Recall Bulletin

File In Section: Product Recalls
Bulletin No.: 04027
Date: May 2004

SUBJECT: DRIVER'S SAFETY BELT ANCHORAGE

MODELS: 2004 CHEVROLET MALIBU AND MALIBU MAXX

1600805

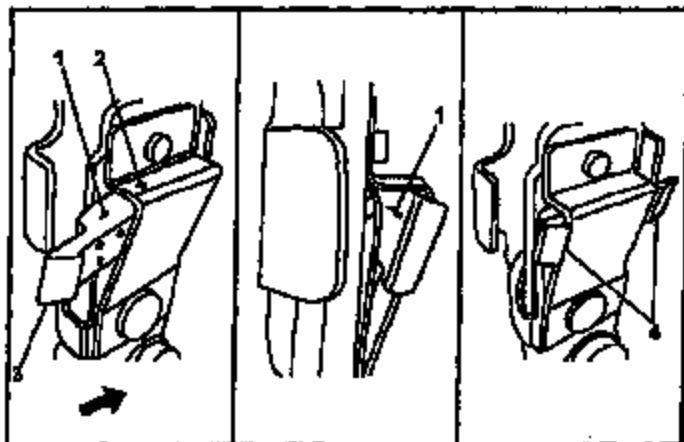
1. Open the driver's door and locate the seat belt webbing (3) lower attachment point (2) directly below and inboard of the seat recliner handle (1).
2. Raise the seat recliner handle to access the opening in the seat belt connector (4).
